Ref: 20757L02cPKmdw

Response to Environmental Health – Noise Impact Assessment to support Reserved Matters Application for 1 Unit and 3 Unit Layout: Project Velocity, Stanbridge Road, Havant, Hampshire.

This letter forms a technical response to the planning consultation responses (ref: APP/15/00284) issued via e-mails by Mr. David Fitzgerald¹, Environmental Protection Manager of East Hampshire District Council on behalf of Havant Borough Council. This is with respect to noise associated with the proposed 1 Unit and 3 Unit proposals for the Project Velocity development at Stanbridge Road, Havant in Hampshire.

Figure A3: Screenshot of SoundPLAN© calculation with reflective fence – Unit 1 Scheme.

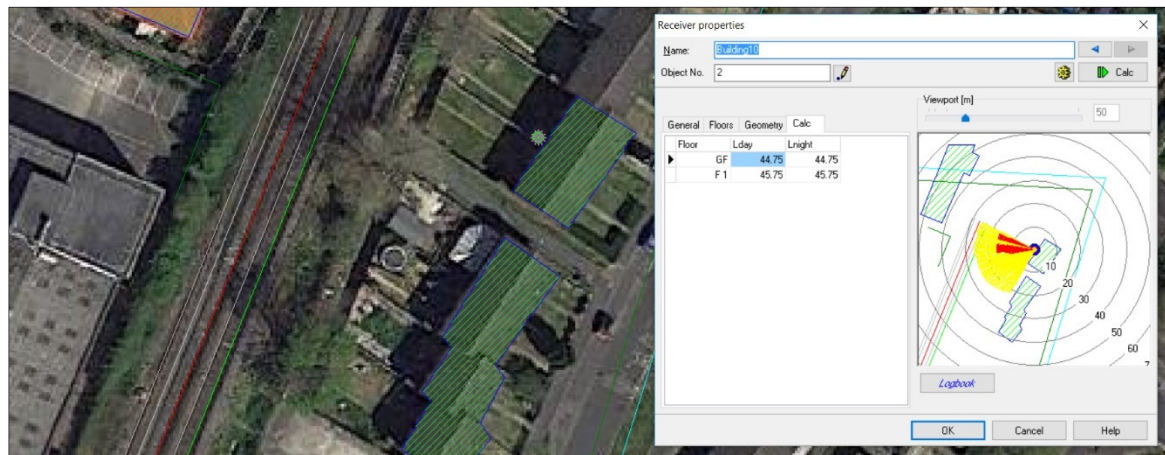
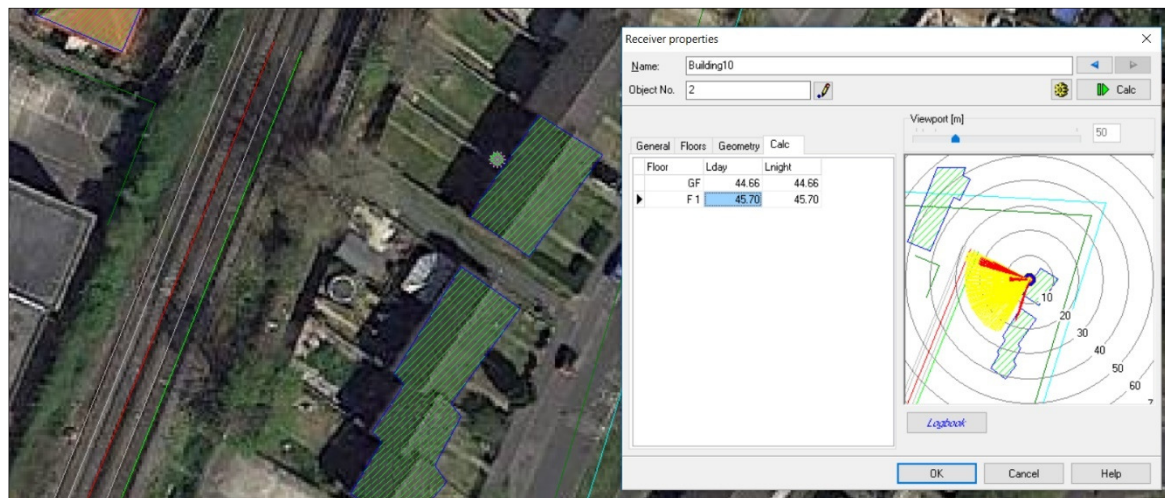
There will an increase in the noise level from the site, the assessment shows the issues will have an impact during the night-time period. The mitigation that is proposed is the installed is a 2.4 metre high fence along the boundary with the railway line. My concern and the ultimate issue is the construction of the fence is not appropriate, as the specification does not take into account the reflective noise off of the railway line, now heading towards the properties in Nutwick road, causing increase noise levels from the railway traffic.

The design of the proposed 2.4 metre high fence needs to be resubmitted with the railway line façade being constructed of absorbent material, thereby reducing the impact of reflective noise caused from trains, Other alternative solutions will be considered if they provide the same end result.

- 2.3.1 Table 2.2 provides details of the calculated noise levels at the nearest dwellings on Nutwick Road with a reflective fence an absorptive fence, and a comparison between the two. Figures A3 and A4, Appendix A shows a SoundPLAN© image of the calculated results.
- 2.3.2 Please note, for a robust assessment, the calculations in Table 2.2 do not include any potential shielding of reflected noise by the trains themselves.

- 2.4.1 As can be seen in Table 2.2, reflected noise levels at the nearby dwellings are 0.1dB(A) more with the proposed reflective fence when compared to that with the absorptive fence. A difference of 0.1dB(A) is considered negligible where a minimum 3dB difference is generally considered in the industry to be just noticeable to someone with good hearing under normal listening conditions⁵. We therefore consider that the difference in the level of noise impact as the dwellings on Nutwick Road due the absorptive fence compared to the proposed reflective fence would be negligible.

- 2.5.2 We conclude that there would be a negligible change in impact at the dwellings on Nutwick Road due to the proposed reflective fence for both schemes and the requirement for an absorptive fence is therefore not justified.

Figure A5: Screenshot of SoundPLAN© calculation with reflective fence – Unit 3 Scheme.

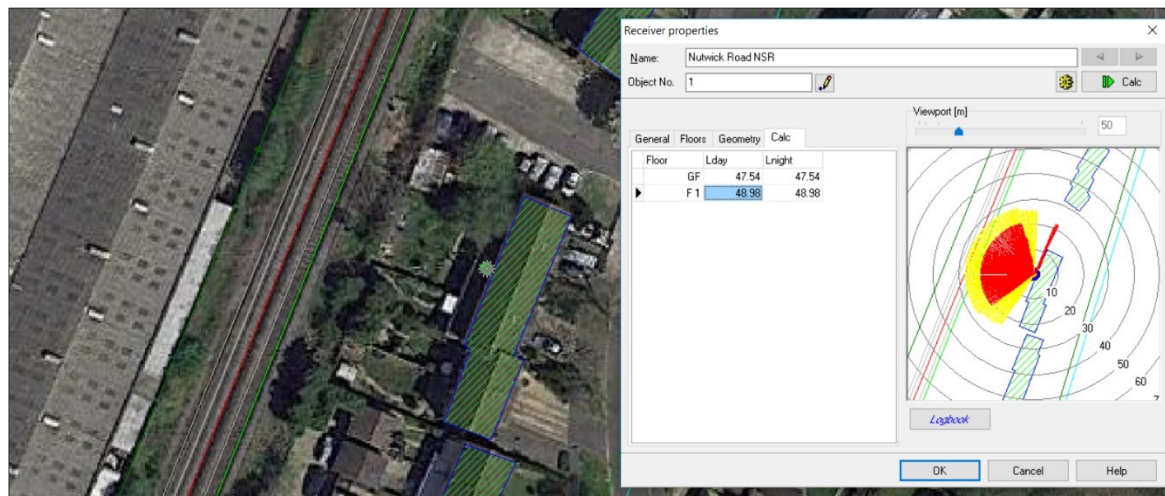
There will an increase in the noise level from the site, the assessment shows the issues will have an impact during the night-time period. The mitigation that is proposed is the installed is a 3 metre (eastern boundary) and 2.4 metre (south eastern boundary) high fence along the boundary with the railway line. My concern and the ultimate issue is the construction of the fence is not appropriate, as the specification does not take into account the reflective noise off of the railway line, now heading towards the properties in Nutwick road, causing increase noise levels from the railway traffic.

- 2.3.3 Table 2.3 provides details of the calculated noise levels at the nearest dwellings on Nutwick Road with a reflective fence an absorptive fence, and a comparison between the two. Figures A5 and A6, Appendix A shows a SoundPLAN© image of the calculated results.
- 2.3.4 Please note, for a robust assessment, the calculations in Table 2.3 do not include any potential shielding of reflected noise by the trains themselves.

- 2.4.2 As can be seen in Table 2.3, reflected noise levels at the nearby dwellings are 0.8dB(A) more with the proposed reflective fence when compared to that with the absorptive fence. A difference of 0.8dB(A) is considered negligible where a minimum 3dB difference is generally considered in the industry to be just noticeable to someone with good hearing under normal listening conditions. We therefore consider that the difference in the level of noise impact as the dwellings on Nutwick Road due the absorptive fence compared the proposed reflective fence would be negligible.
